Consolidation Coal Company  
Mid-Continent Region  
12755 Olive Boulevard  
St. Louis, Missouri 63141  
(314) 275-2300

Consolidation Coal Company proposes to revise the Emery Deep Mine permit application (ACT/015/015) to add another mining panel as shown on the attached map (Plate 3-7). This revision is insignificant in that the conditions of UMC 788.12(a) are not applicable.

The proposal from Consolidation Coal for a minor modification of the approved mine plan of the Emery Deep Mine, received May 16, 1987, has been reviewed by this office.

Consolidation Coal Company (Consol) proposes to amend and modify the approved Emery Deep Mine (ACT/015/015) Permit Application Package (PAP) to allow the construction and use of a second borehole pump facility. This facility will improve the efficiency of water management within the mine, thereby increasing safety and general working conditions.

# CULVERT INSTALLATION

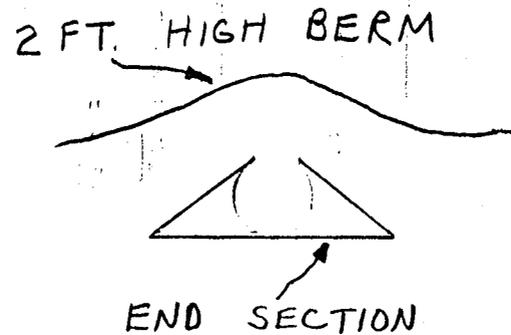
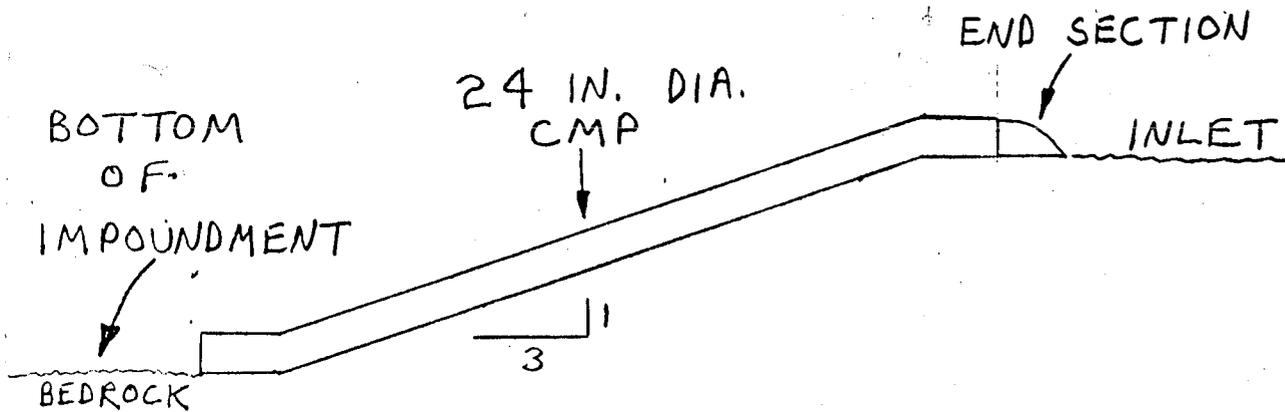
The contributing drainage area in question is 15.5 acres (as shown on the enclosed map). The peak flow in this area for a 10 yr-24 hr event would be 6.2 cfs and could be transmitted through an 18-inch diameter culvert without entrance head. The peak flow for a 100 yr - 24 hr event would be 15.6 cfs and could be transmitted through the 18-inch culvert with about 2.7 ft. of head. Comparatively, a 24-inch diameter culvert would flow about two-thirds full for the 10 yr - 24 hr event and would have about 0.4 ft. of entrance head under the 100 yr - 24 hr peak flow condition. In view of the erratic frequency of storms in this area of Utah, Consol has decided to use a 24-inch diameter culvert.

CULVERT INSTALLATION  
OF SED. POND # 5

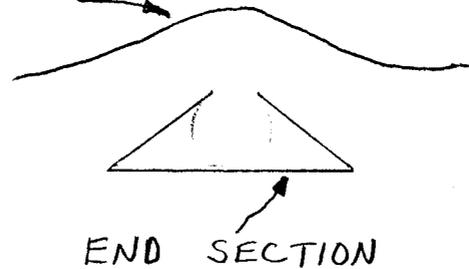
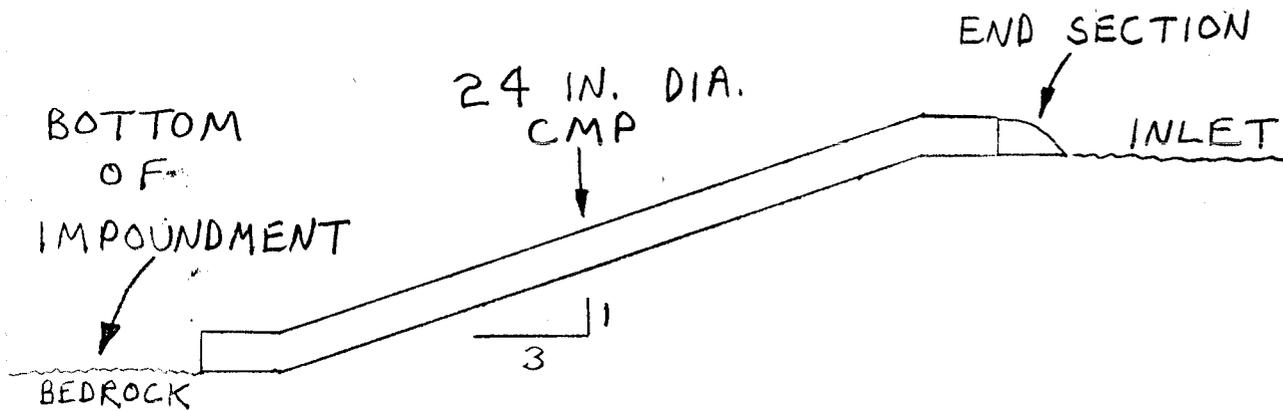
The contributing drainage area in question is 15.5 acres (as shown on the enclosed map). The peak flow in this area for a 10 yr-24 hr event would be 6.2 cfs and could be transmitted through an 18-inch diameter culvert without entrance head. The peak flow for a 100 yr - 24 hr event would be 15.6 cfs and could be transmitted through the 18-inch culvert with about 2.7 ft. of head. Comparatively, a 24-inch diameter culvert would flow about two-thirds full for the 10 yr - 24 hr event and would have about 0.4 ft. of entrance head under the 100 yr - 24 hr peak flow condition. In view of the erratic frequency of storms in this area of Utah, Consol has decided to use a 24-inch diameter culvert.
